RENESAS TECHNICAL UPDATE

Classification of Production	MPU&MCU		No	TN-SH7-497A/E	Rev	1
THEME	Modification of the Reset Sequence of HCAN2 of SH7760		Classification of Information	<ol style="list-style-type: none"> 1. Spec change ②. Supplement of Documents 3. Limitation of Use 4. Change of Mask 5. Change of Production Line 		
PRODUCT NAME	SH7760	Lot No.	Reference Documents	SH7760 hardware manual (ADE-602-291)	Effective Date	
		All			Eternity

- The figure 22.5 Reset Sequence of the 22.6.2 HCAN2 Settings

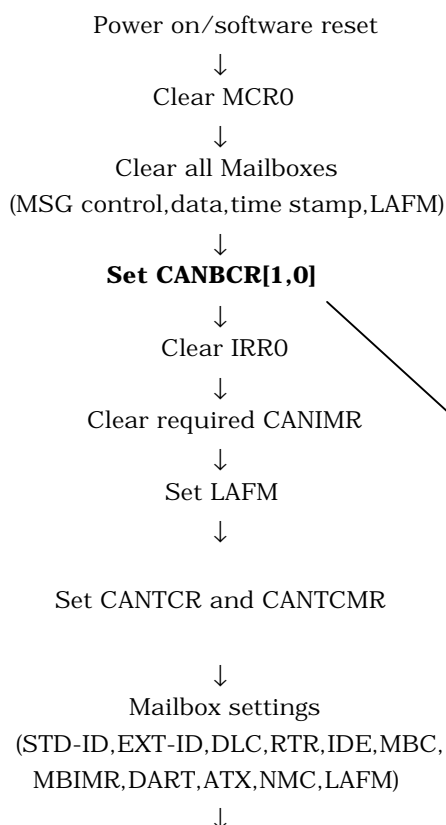
There is the following modification about the Reset Sequence of HCAN2 of SH7760.

Please set CANBCR[1:0] immediately after the Mailbox Setting.
